From: Rebecca David
Sent: Thursday, 31 October 2019 10:55 AM
To:
Cc:
Subject: MRAC0101_Mutkin_Hydraulic Drawings_QA Rejected
Importance: High

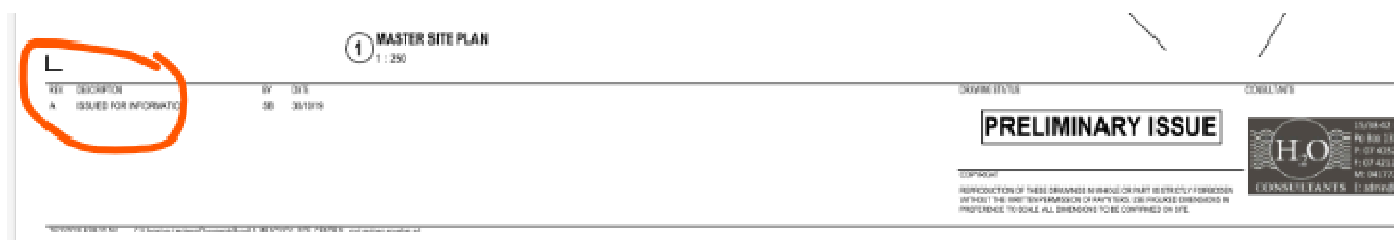
- Change the revision on your title block to alpha and ensure both sections have the same revision (see orange circles)
- When uploading ensure Design Only – Coordination is picked (green circle)
